April 20, 2021

### Evolution Door Latch Advisory:

Figure 15.2.D.3 Latch and Anchor Alignment

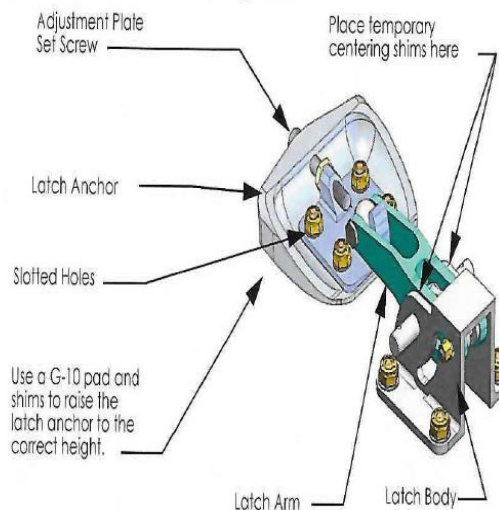
Before the next flight ensure that all seven latch balls fully seat in their sockets. You may have to remove the pilot seat to assess that they do seat properly. There should be no clearance

between the ball and socket. This can be determined using a feeler gauge and a flashlight. Be aware that temperature differences can influence the ball and socket fit—so if your locale experiences wide temperature swings ensure you check ball and socket fit again when temperatures swing.

Original spline drive pictured on top. Current, preferred, coupler system on bottom.

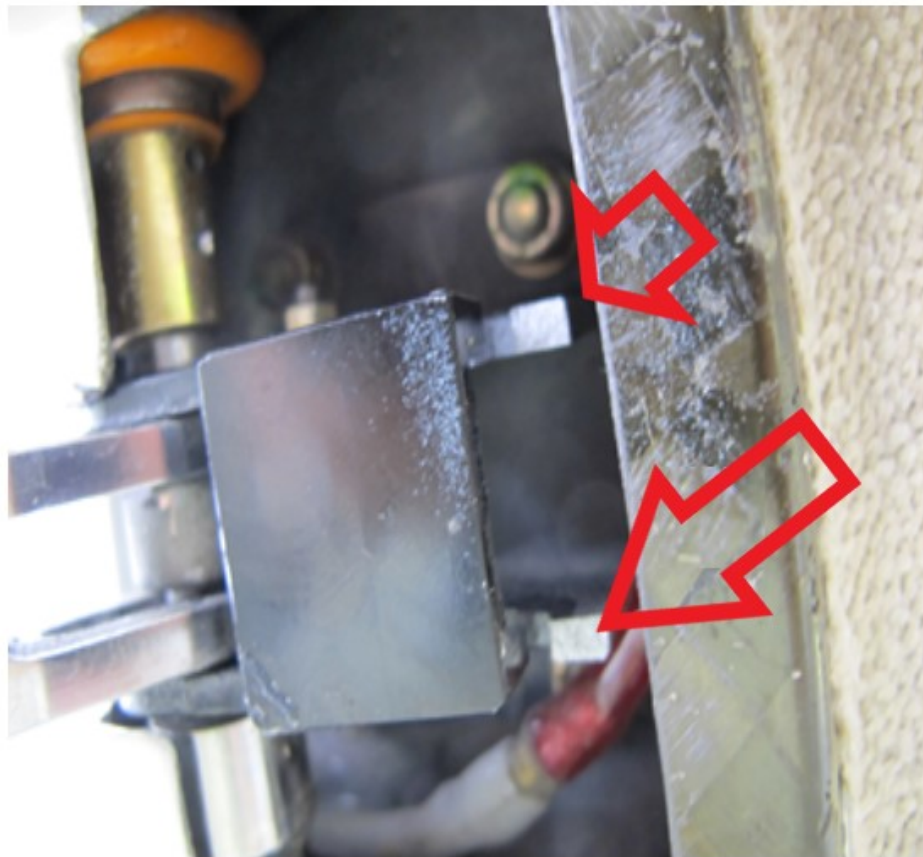
A few original Evolution kits had a non-adjustable latching system. Later Evolutions have an adjustable latching system so that if one ball is not seating properly then it can be adjusted independently of the others by your maintenance shop. The original system cannot be adjusted. A retrofit to the latest Evolution adjustable door latching system is recommended. Determine which system you have.

Worn hinge pin pictured.

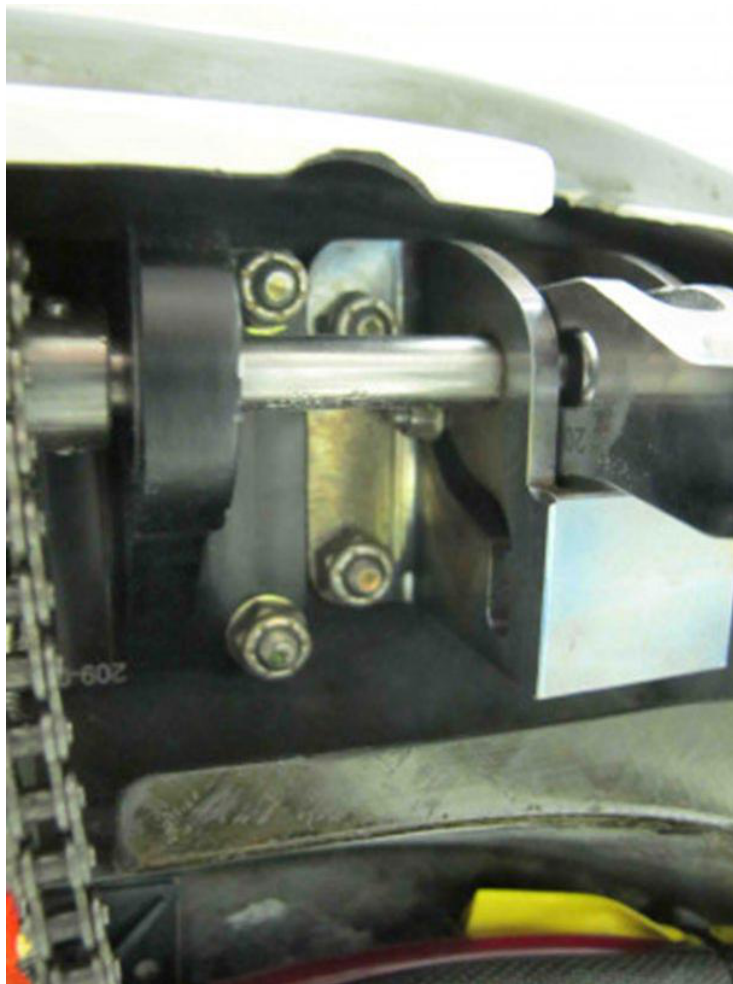
Annually, during your condition inspection, have your maintenance shop carefully check your door latch system by noting the contact between the ball and socket with a feeler gauge and make adjustments to ensure a proper fit in accordance with Evolution Build Manual page 15-10, paragraph 5). Additionally, since your two door hinges are part of the door system, they should be removed and the pin should be removed and inspected for wear. Replace worn hinges.
